19908619

APPLICATION FOR IMPROVEMENT PERMIT FOR RESIDENTIAL SITE INDIVIDUAL WATER AND WASTEWATER SYSTEMS PROGRAM

FILE #: 3404-A

TAX/PARCEL NUMBER: 199-086-19

3404 PA

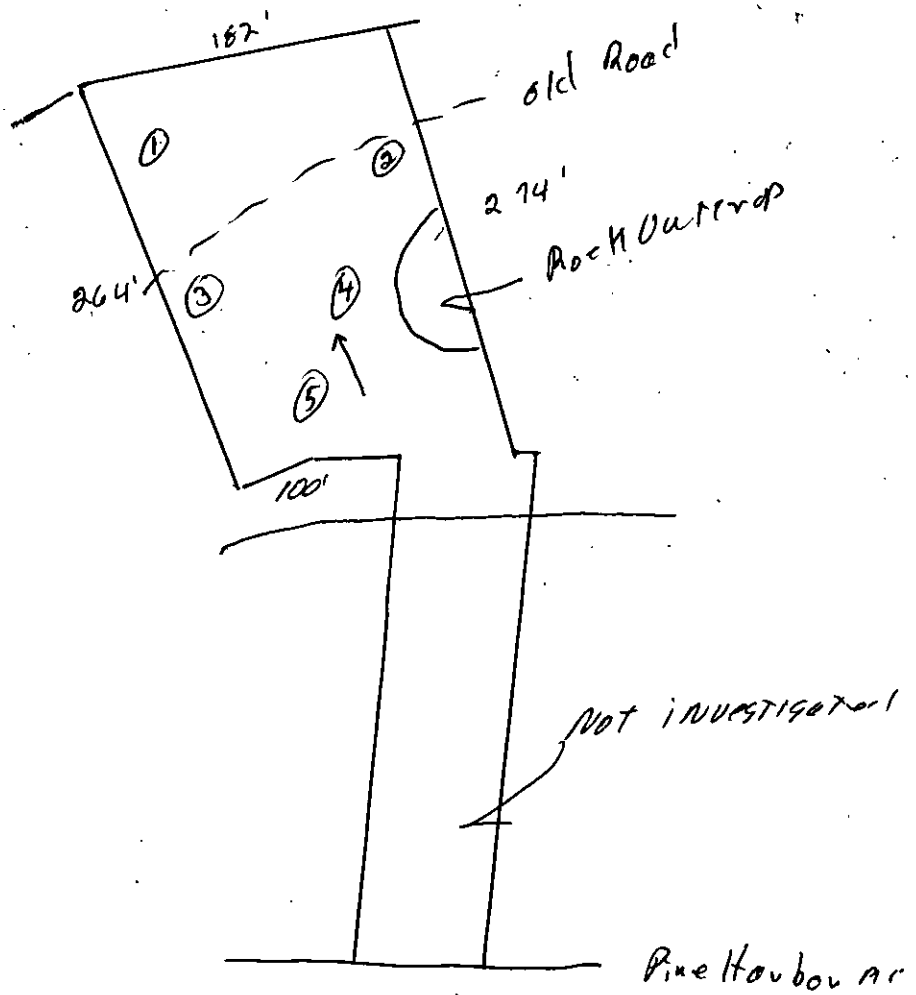
Probably Rock Repair

3404 M

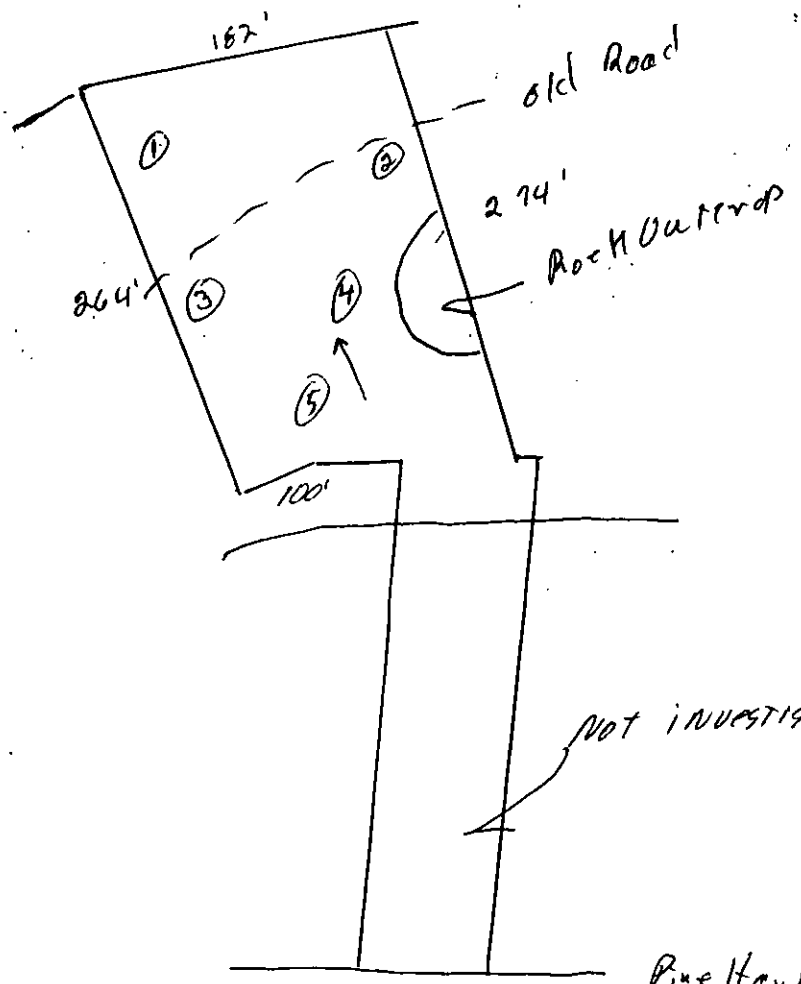
Probably Rock

MECKLENBURG COUNTY ENVIRONMENTAL HEALTH File: 3404A Action: /
SITE EVALUATION REPORT
SERIAL NUMBER 14130 Parcel: 19908601 PO ☐ PC

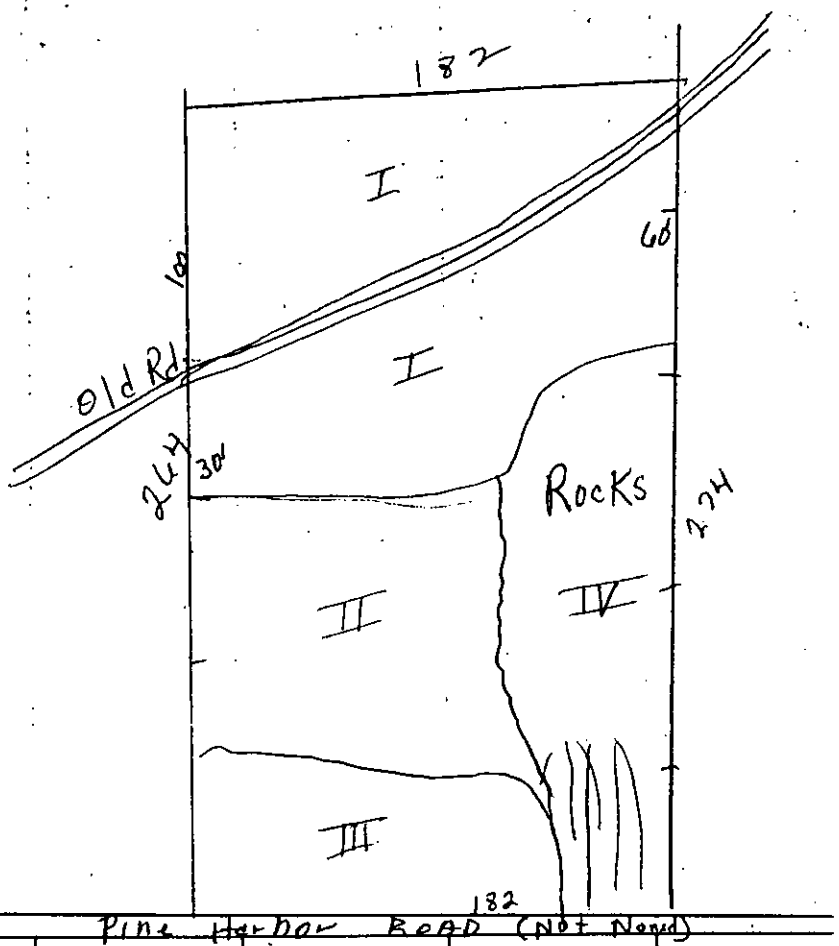
Comments: (1) Need Proof When Lot Recorded
(2) Will Not Be Able To put IN IN old Rd Bed
(3) Useable Area is limited — Cut up by road + Different Elevations.

PLOT OF SYSTEM

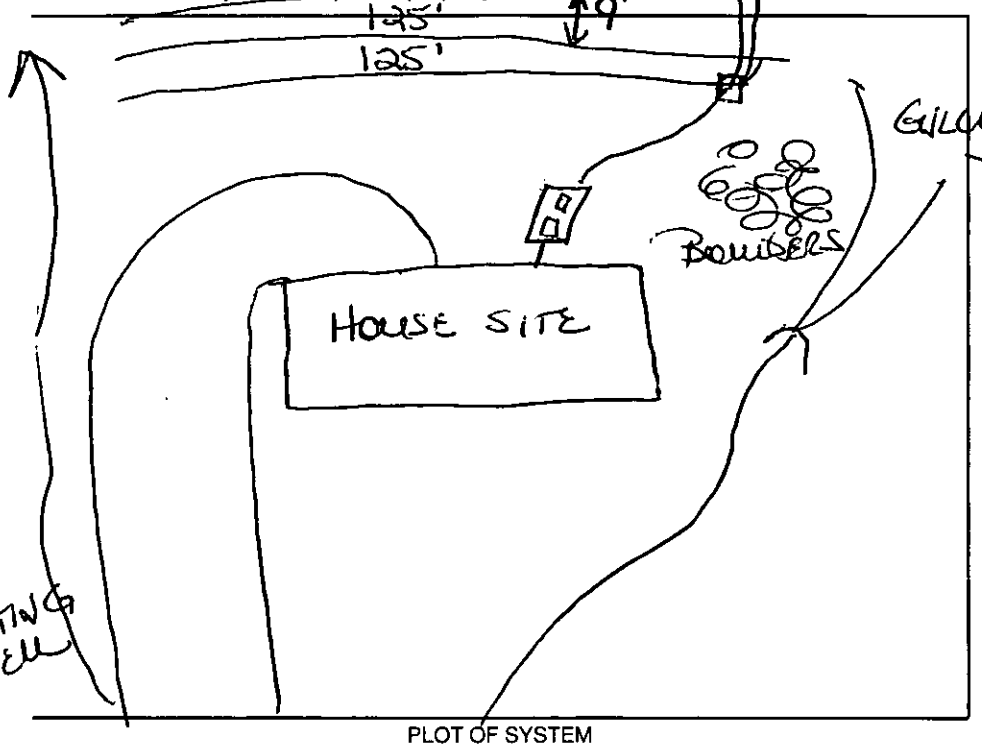
Comments: 1500 SEPTIC TANK, 4 LINES @ 125'
CHAMBERED SYSTEM - (1) DBOX WITH SPEED LEVELERS
① MINIMUM 24" TRENCH AT BOTH SIDES OF TRENCH
② ALL DRAINS, ALL SURFACE DRAINAGE TO BE INSTALLED AWAY FROM SYSTEM -
PRIOR TO FINAL RELEASE.

PLOT OF SYSTEM

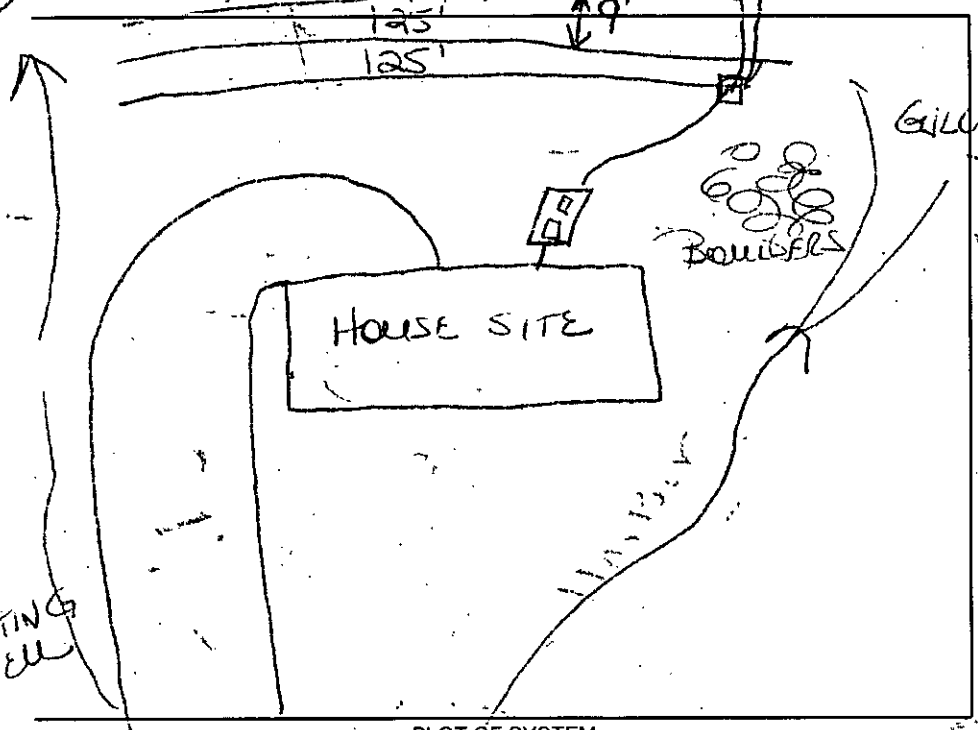
Comments: 1500 SEPTIC TANK, 4 LINES @ 125'
CHAMBERED SYSTEM - (1) DBOX WITH SPEED LEVELERS
① MINIMUM 24" TRENCH AT BOTH SIDES OF TRENCH
② ALL DRAINS, ALL SURFACE DRAINAGE TO BE INSTALLED AWAY FROM SYSTEM -
PRIOR TO FINAL RELEASE.
